RE: Comments on Proposed Study Plan: Brunswick Hydroelectric Project (FERC No. 2284).

Comments on Proposed Study Plan:

Figure 5.2.1.5-1: Proposed CFD Model Extents

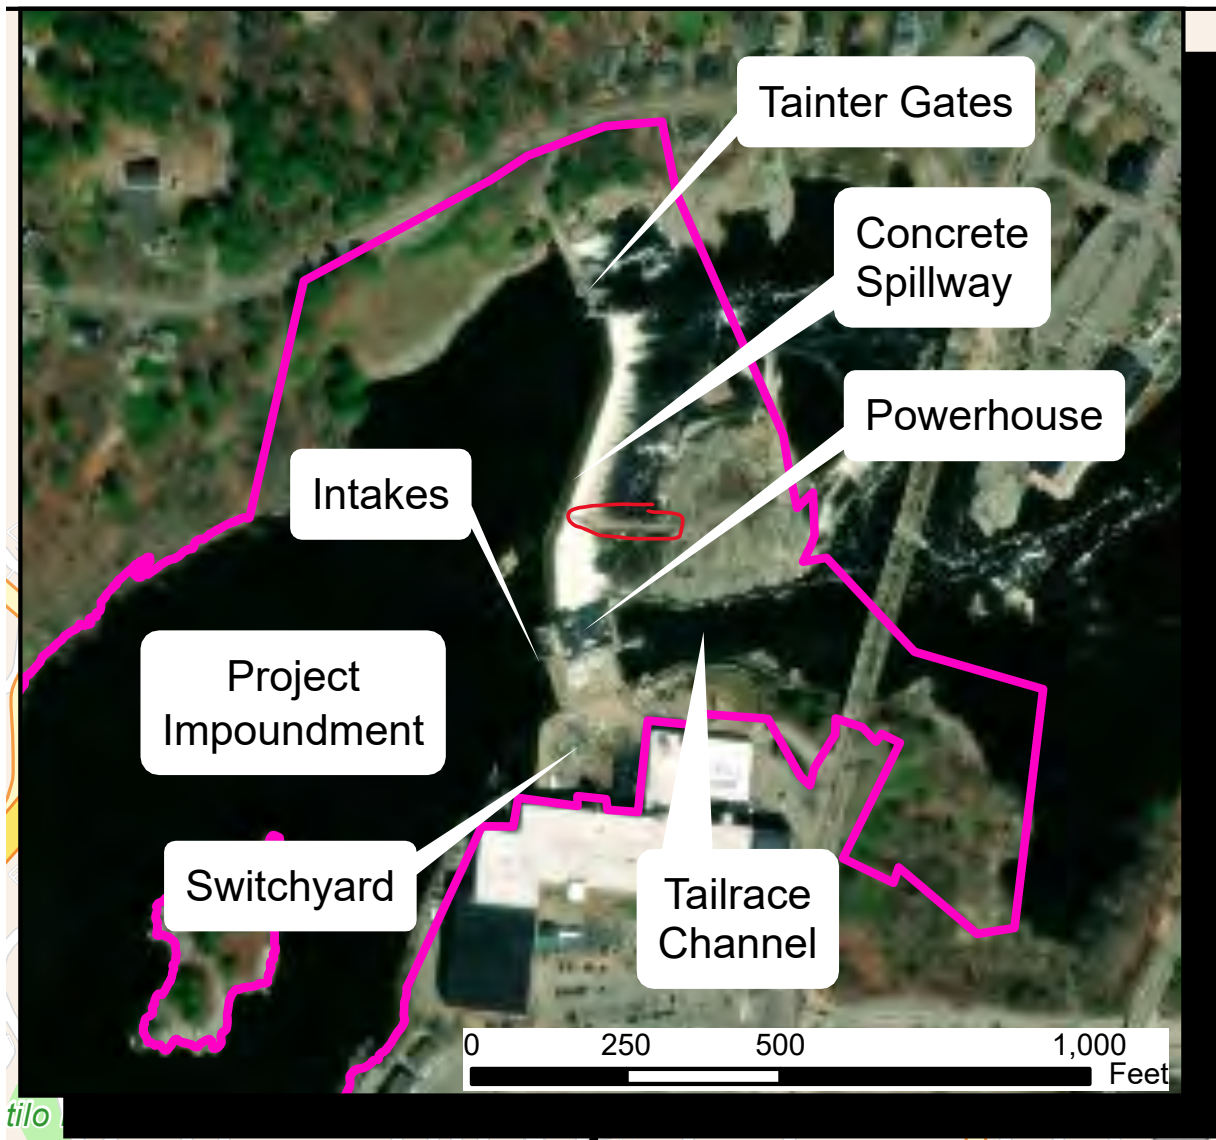
2). **The study parameters need to include data to allow for consideration of a Nature-Like Fishway:** In the PSP’s Section 5.2.1 Computational Fluid Dynamics Modeling - Upstream and Downstream Passage Study, the study parameters for measurement locations downstream are limited to the powerhouse tailrace and do not include downstream flows immediately below the 400 ft section of the dam that acts as an overflow spillway. See Figure 5.2.1.5-1: Proposed CFD Model Extents in the PSP (copied below).

Our concern is that this limitation precludes analysis of flow dynamics and geomorphology below the spillway which is actively passing water most of the year and at times may be creating unintentional attraction flows. Therefore, the ability to consider a Nature-Like-Fishway (NLF) that mimics a more natural environment for fish passage as an alternative fishway design in that very large section of river will be severely limited by lack of data from the currently proposed studies. As a goal in alignment with the Fish Passage Alternatives Study an NLF should be under consideration with the objective of creating data that allows consideration of all reasonable passage options. Therefore, an NLF must be one of the alternatives vetted under the study regimes discussed in section **5.2.2 Upstream and Downstream Fish Passage Alternatives Study** which states:

Please include requirements for consideration of a NLF fish passage design in the spillway area using literature review and real-world examples of methodologies as mentioned for other designs that will only be considered for the tailrace area. This should include literature such as, but not limited to, fishway designs as described in Turek et al 2016¹ and real-world examples in Maine (see Saccarappa Falls example for U.S. Fish and Wildlife Service, Westbrook, Maine <https://www.fws.gov/story/rallying-round-presumpscot>) and beyond. Study conclusions should include reporting of alternative fishway analyses that considers these designs and fully address feasibility relative to other alternatives being considered.
